Service Letter No. 366

SUBJECT: Nose Gear Clevis

MODELS AFFECTED: PA-24 and PA-24 "250" Comanches - Serial Nos. 24-1 to 24-2609 inclusive

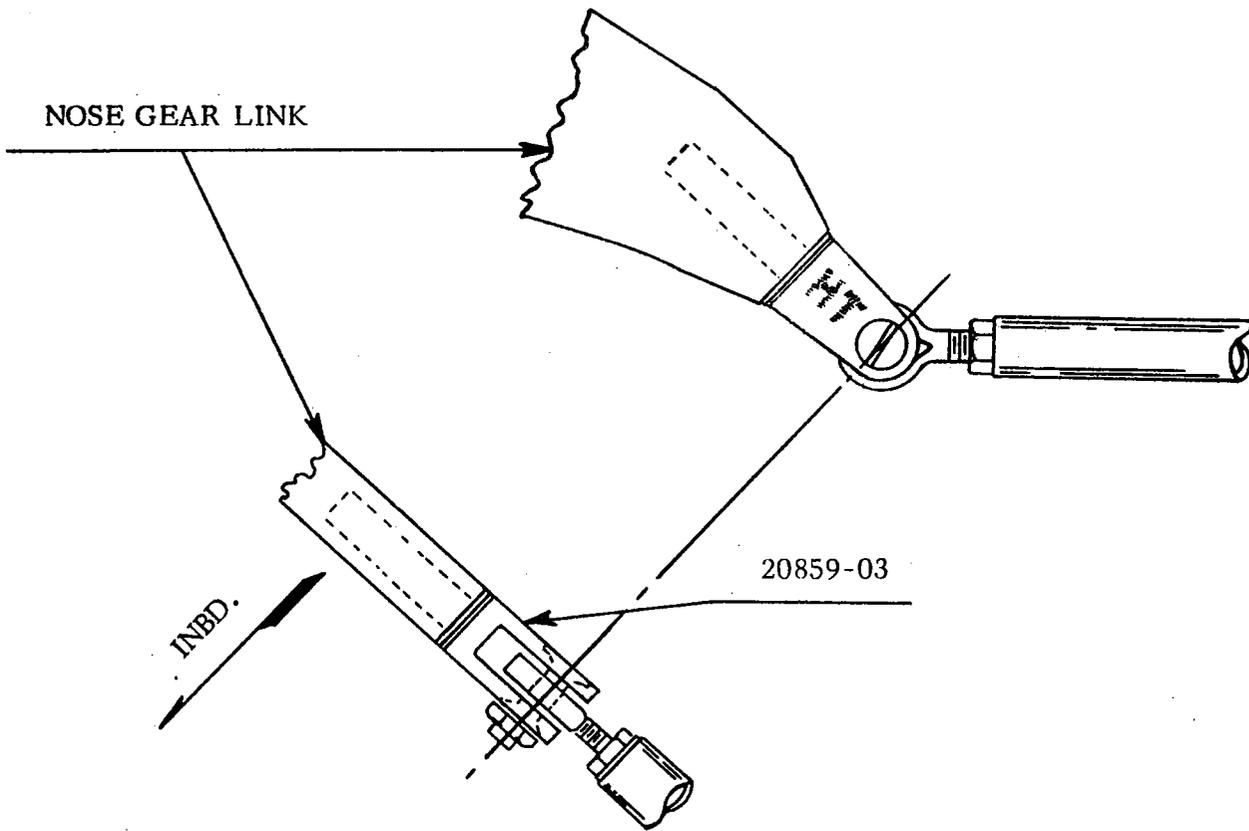
A new high strength nose gear clevis, part number 20859-03, is available to replace the nose gear clevis with which the early models of Comanche aircraft were equipped.

This new clevis may be identified by the letters "H.T." etched on the side of the fitting. We are of the opinion that since this new high strength fitting will provide longer service life, the owners and operators of the affected aircraft should replace the present clevis with this improved one. See sketch on the reverse side of this letter.

This clevis, when installed, must be tight in the forging (13 to 40 ft. lbs. torque) and nut must be inboard.
